1st Review - Please
contact Rifka Wine with
questions.
RWine@bhinc.com

RE: MHFD Referral Review Comments

Project Name: Buckley Yard F2 (RSN 1535413)

BUCKLEY YARD SUBDIVISION FILING NO. 2

VICINITY MAP

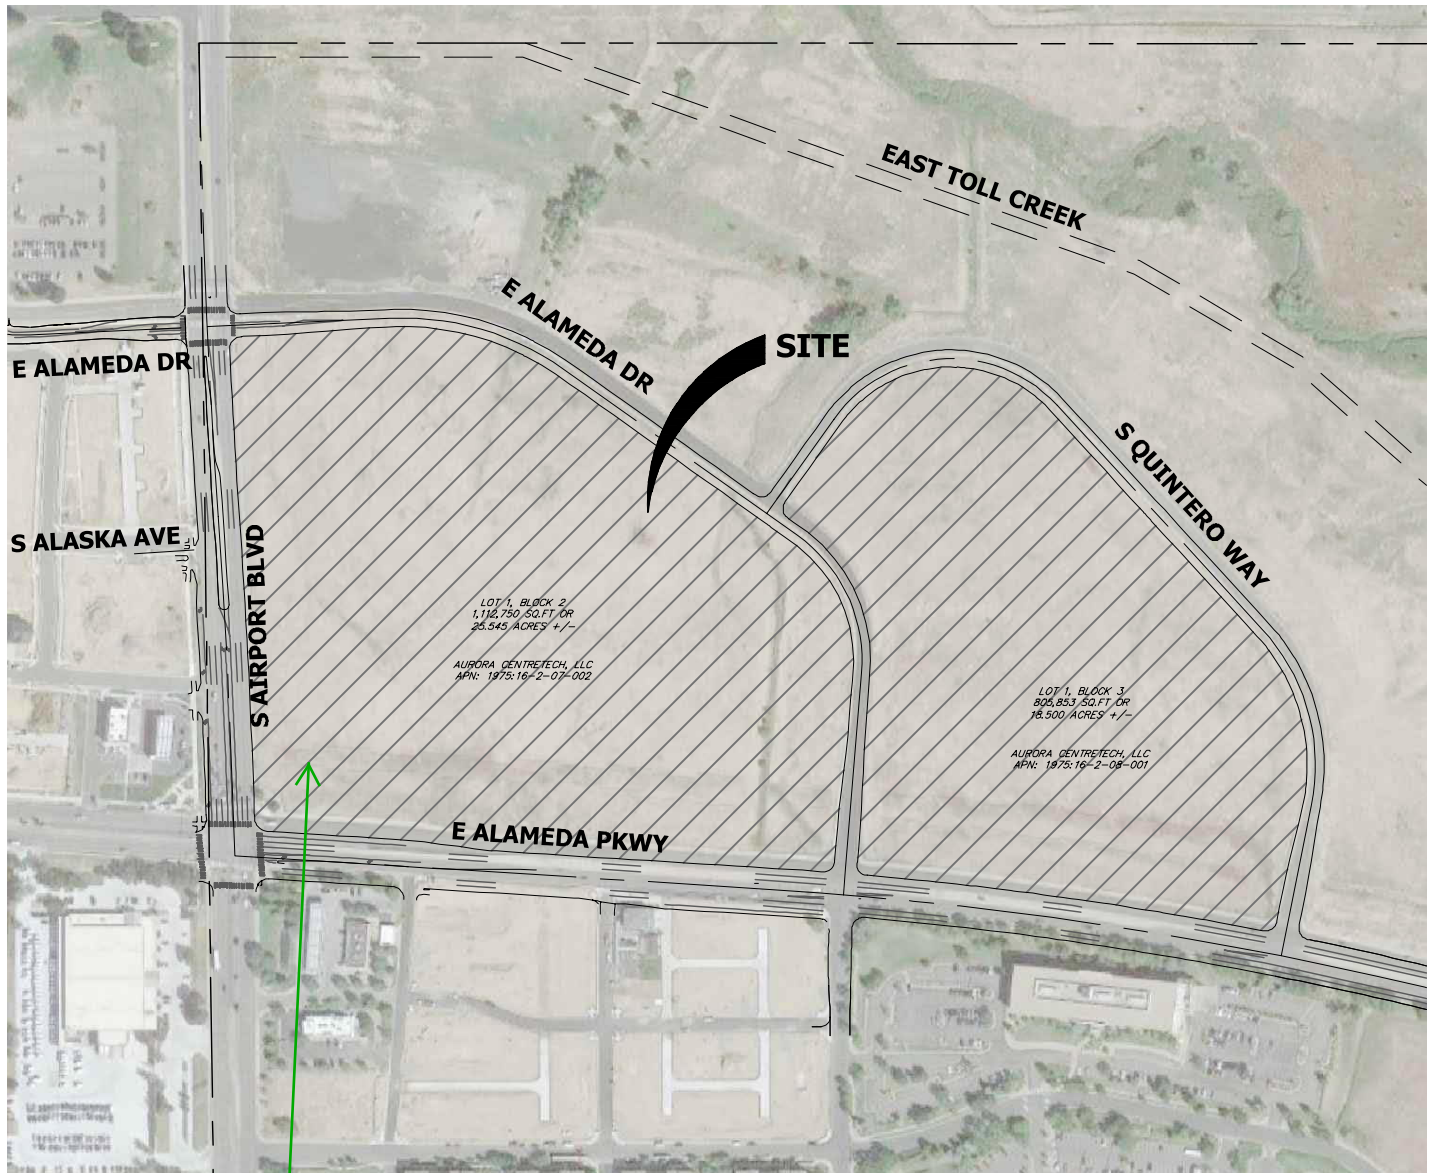
Remove Filing 1
Area from
hatching.

JR Response: Addressed.

PROPOSED CONDITIONS MAP
BUCKLEY YARD
JOB NO. 16044.00
04/12/21
SHEET 2 OF 2

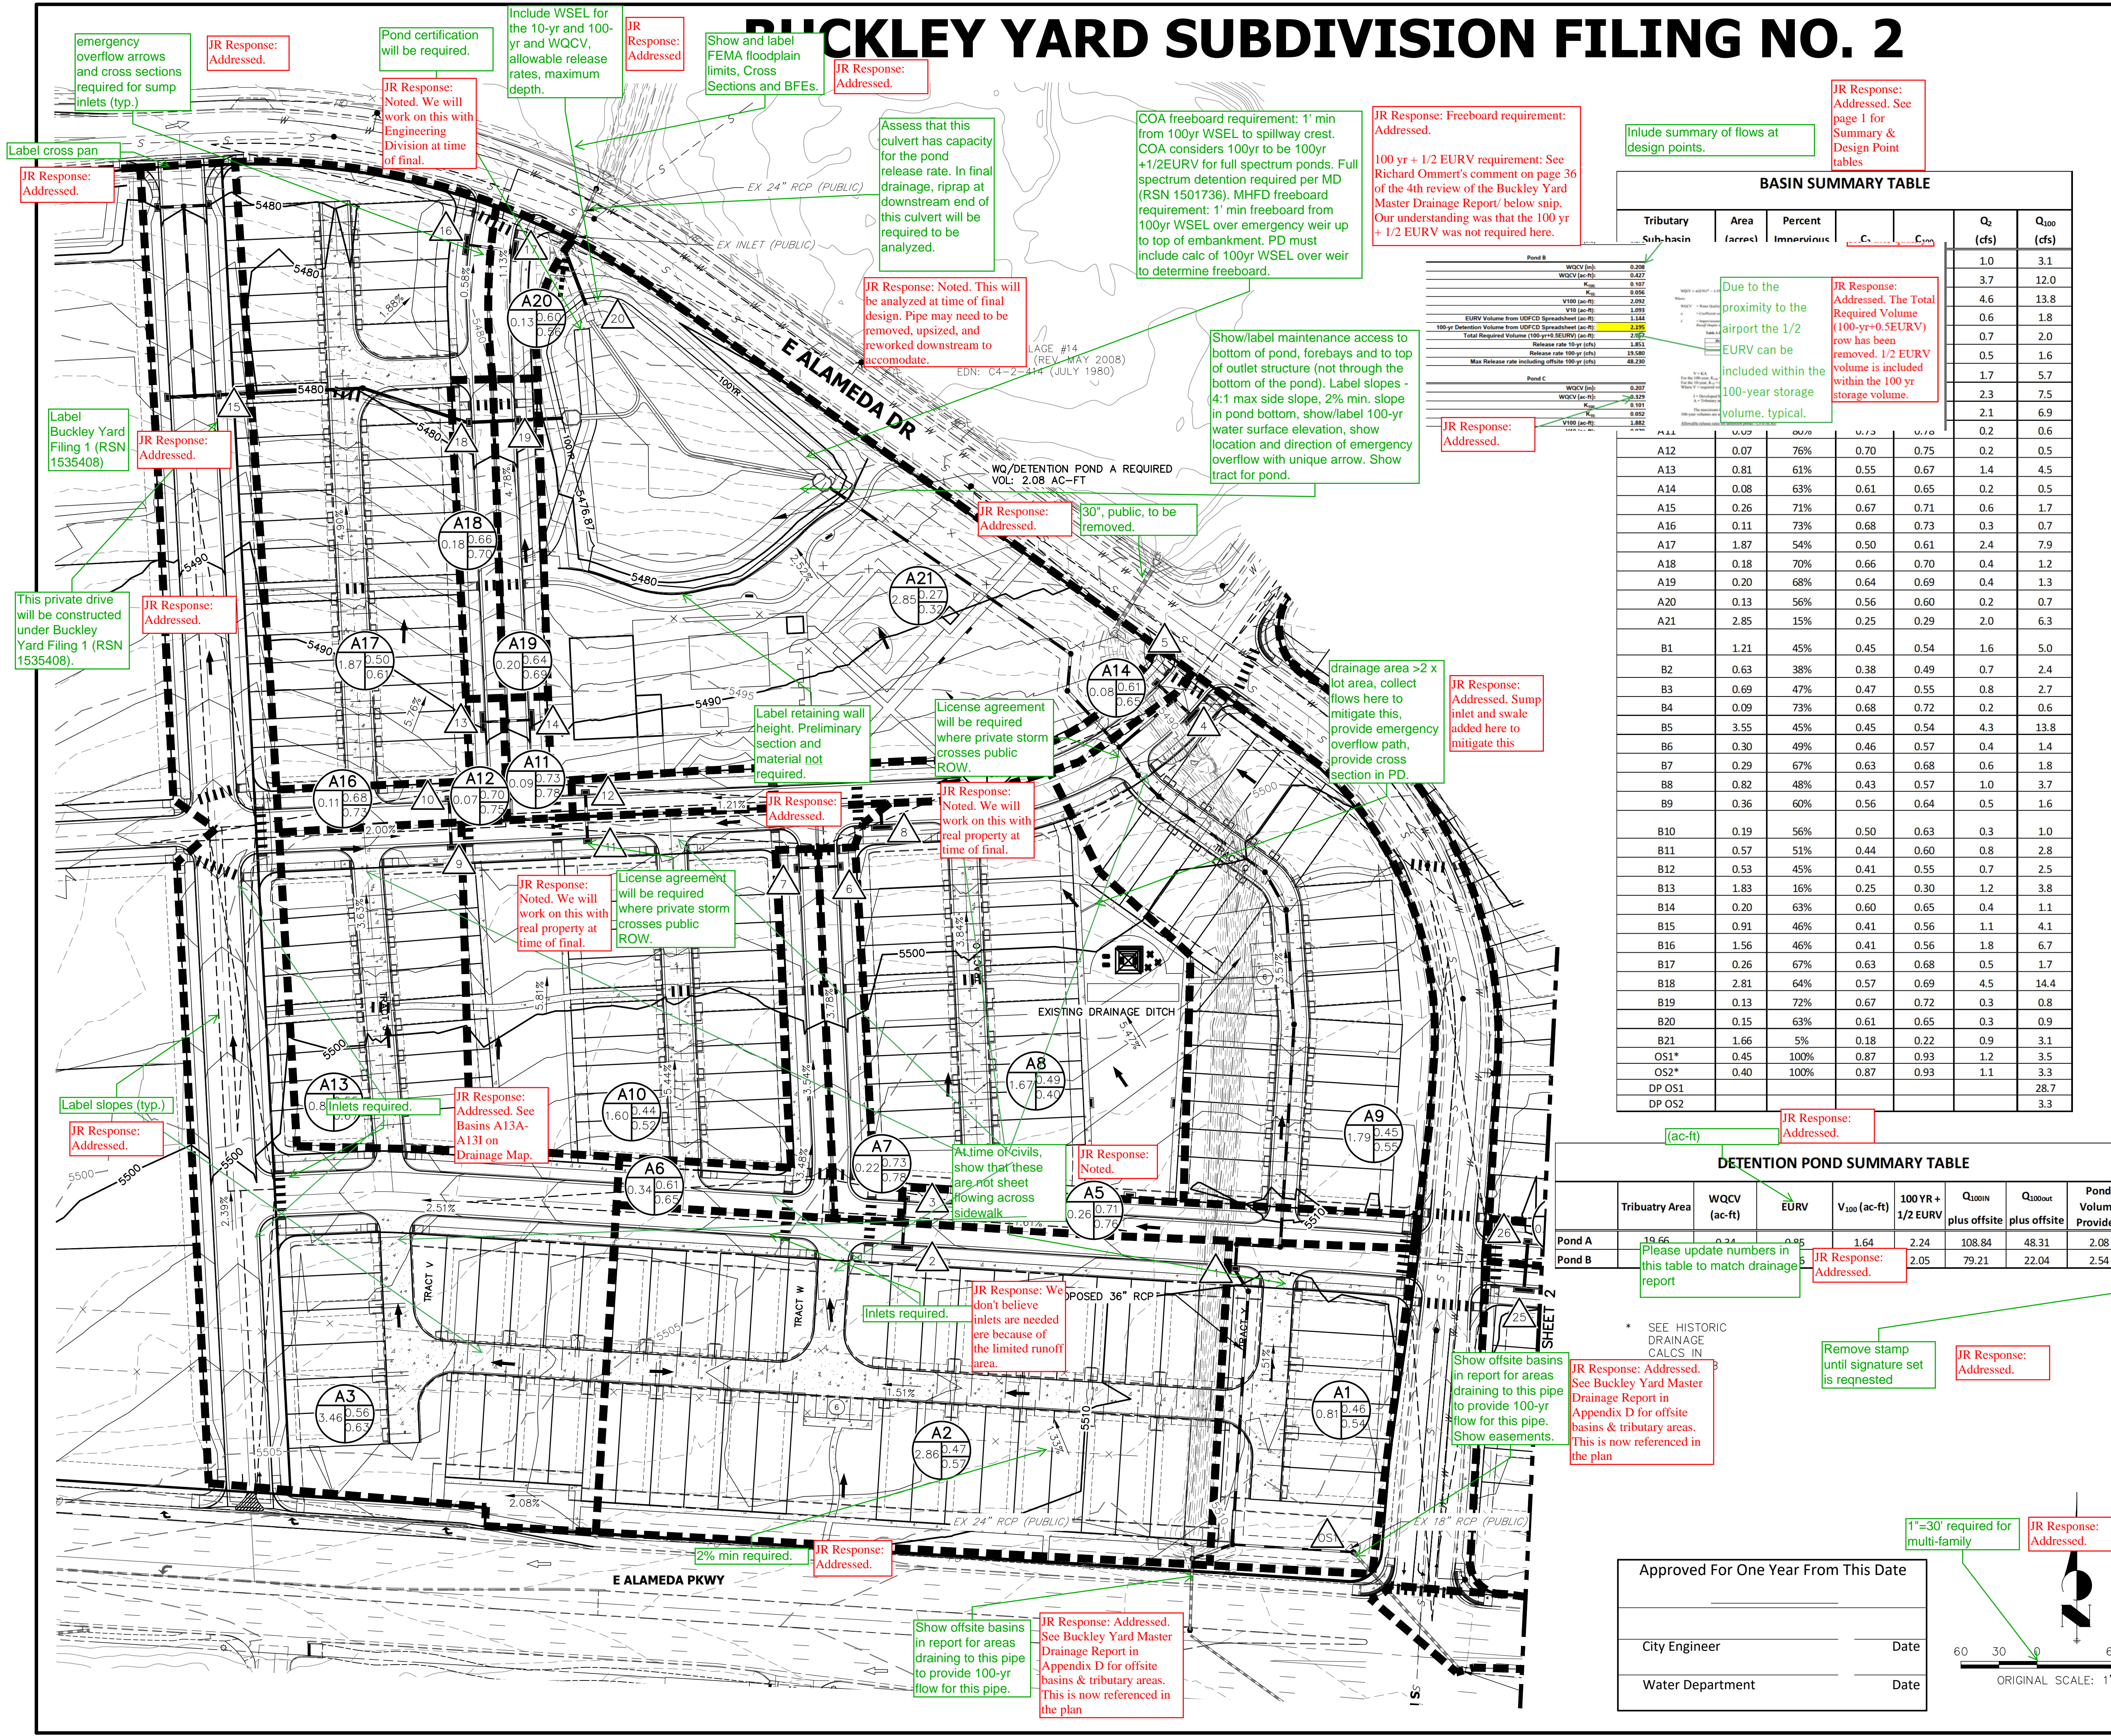
Advisory note: storm drain in alley, potential utility conflicts. How will manholes work in valley gutter, provide details at time of civils.

Floodplain Development Permit will be required. Show setbacks and FFEs for lots adjacent to floodplain. LFEs required to be 2 ft min above BFE. Lots required to be 1 ft min above BFE. Elevation certificates will be required at the time of civil plans for lots adjacent to pond.

Show and label FEMA floodplain limits, Cross Sections and BFEs.

Show/label maintenance access to bottom of pond, forebays, and to top of outlet structure (not through the bottom of the pond). Label slopes - 4:1 max side slope, 2% min. slope in pond bottom, show/label 100-yr water surface elevation, show location and direction of emergency overflow with unique arrow. Show tract for pond.

Show flow direction arrows

Show, dimension, and label ROW, existing and proposed easements (drainage, utility, fire land, etc.), and tract dimensions.

emergency overflows required for sump inlets (provide cross section and flow arrow, show that it can overtop high point in street, place top of foundation above that)

At time of civils, show that it is not sheet flowing across sidewalk.

Remove stamp until signature set is requested

This is only required on first sheet of drainage plan.

JR Response: Noted. The permit will be processed at the time of final design. Finished floor elevation will be a minimum of 2' above the BFE and lots will be a minimum of 1' above the BFE.

JR Response: Noted. We will work on this at time of final design.

JR Response: See page 1 response.

JR Response: Addressed.

JR Response: Addressed.

JR Response: Addressed.

JR Response: Addressed. See Appendix C sump inlet overflow cross sections.

JR Response: Noted.

JR Response: Addressed.

JR Response: Addressed.
